Re: Lot 17 Block 7 SAD 228

Volcano Cliffs Subdivision Unit 18

6527 Papagayo Rd. NW Grading and Drainage Plan

Based on the Certification received 12/24/2022, the site cannot be accepted for release of Certificate of Occupancy by Hydrology until the following comments are addressed.

6527 PAPAGAYO ROAD N.W. GRADING AND DRAINAGE PLAN

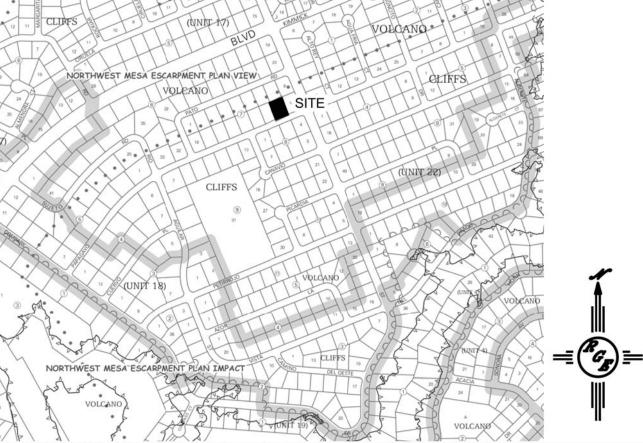
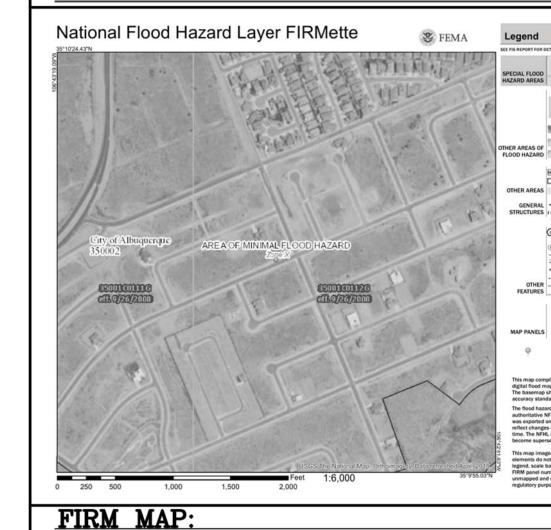
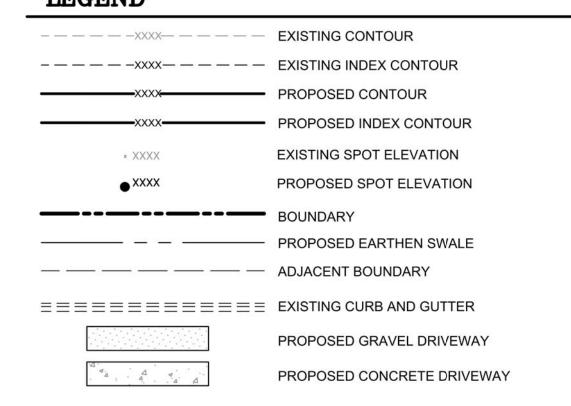
All ponding areas and swales need to have gravel in place.
